FINAL Remedial Design Work Plan and 90% Design Drawings Former Griffiss Air Force Base Rome, New York

- SUBJECT: On-Base Groundwater, Areas of Concern Final Remedial Design Work Plan, 90% Design Drawings
- Enclosed for your review are the On-Base Groundwater Areas of Concern, Final Remedial Design Work Plan and the 90% Design Drawings. The documents are provided in support of pending remediation work at the former Griffiss AFB. Please note that the associated Draft Record of Decision (ROD) was provided for NYSDEC and USEPA review on February 8, 2008.
- 2. Should any questions arise, please feel free to contact Ms. Catherine Jerrard at (315) 356-0810.

Date:		ENGINEERING / DOCUMENT REVIEW	
12/10/200 7		Griffiss OBGW Project	Document: <u>Draft Remedial Design Work Plan</u> (RDWP) and 30% Design Drawings Former GAFB

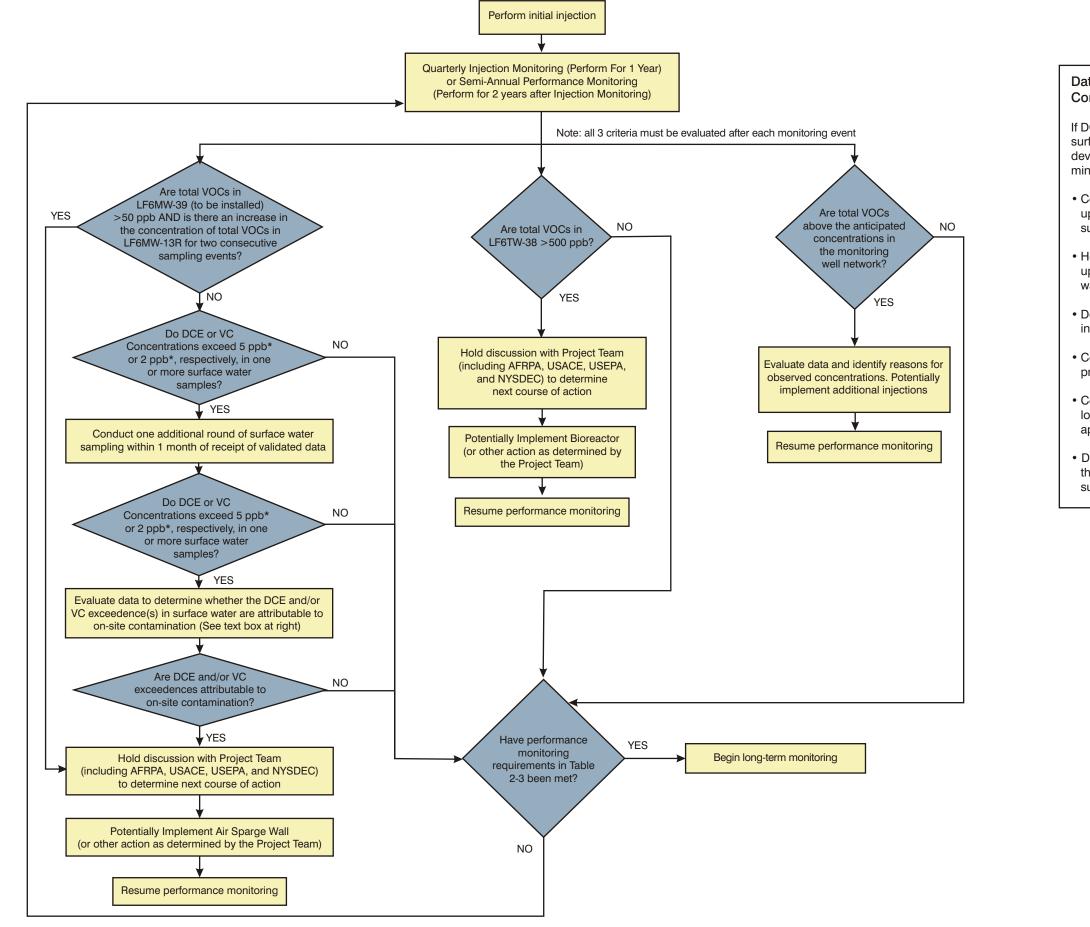
8	Figure 2-1, Decision Process for Contingency Plan Implementation, Landfill 6 Site, Pages 2-13 and 2-14	The flow path of the decision tree lists the decision criteria as "Total VOCs above the anticipated concentrations in the monitoring well network." These values are based on a sliding scale as described in Table 2-2, Attenuation Rates of COCs at the Landfill 6 Site. Ensure that in future design submittals this information is translated into a decreasing trend table for ease of reference.	The calculated total VOC concentrations presented in Appendix A will also be presented in either graphical or tabular format in future evaluation reports associated with this site for comparison purposes with recent data collected. Text will be added to Section 2.5.1 to ensure this information is included in future reports as requested.

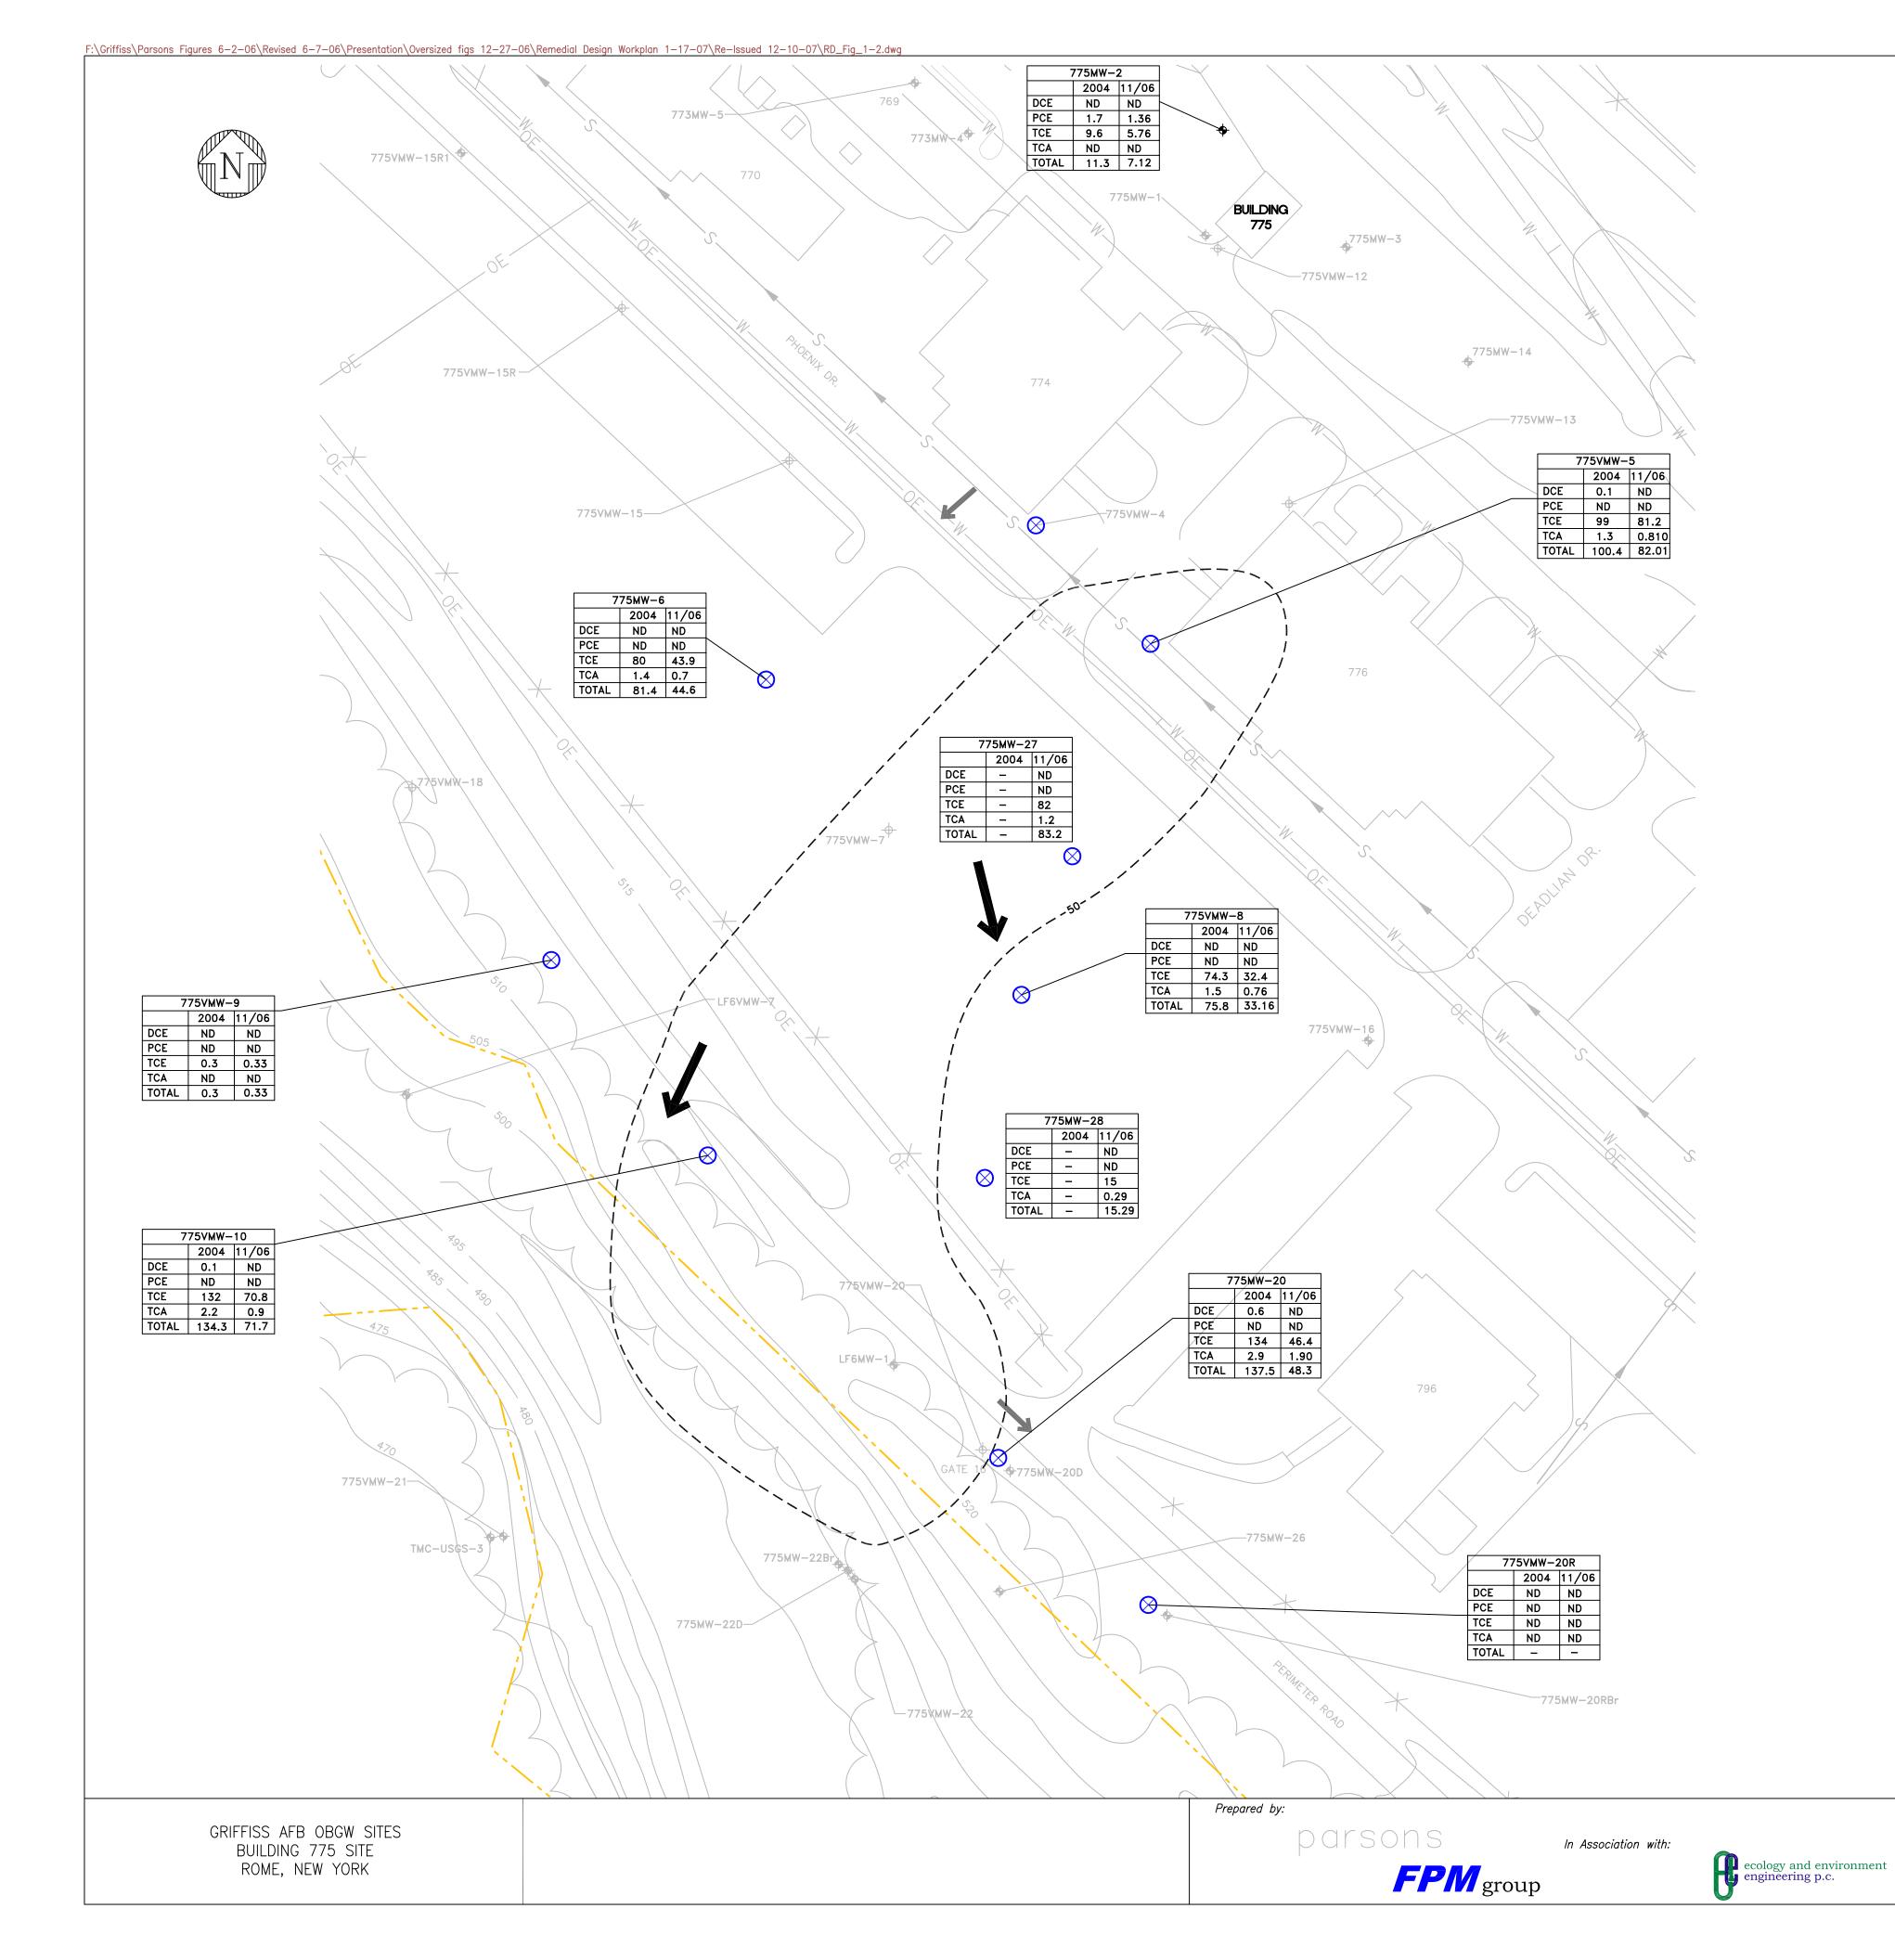
Comment No	Reference (Page and Para)	Comment	Response
9	Draft RDWP Figure 1-1, Landfill 6, Total VOC Concentration Map	The second note on this drawing indicates that, "The non-detect contour is approximated based on 2000 groundwater data. The 50 ppb and higher total chlorinated VOC contours approximated based on 2006 and 2007 groundwater data." This approach seems problematic, as the plume conditions have most likely changed over the last 7 years and we should have a complete round of sampling results. If we do not have a complete round of sampling results, the Draft RDWP should include a discussion that includes a sensitivity analysis as to why the collect of a concurrent round of groundwater data is unnecessary.	The non-detect contaminant contour will be updated on both Figure 1-1 and the Landfill 6 design drawing to reflect the most current analytical groundwater data available (Landfill 6 post-closure monitoring since June 2006). In future evaluation reports, analytical data from the Landfill 6 OBGW and Landfill 6 post- closure long-term monitoring events will be reviewed to update the contaminant contours for this site.
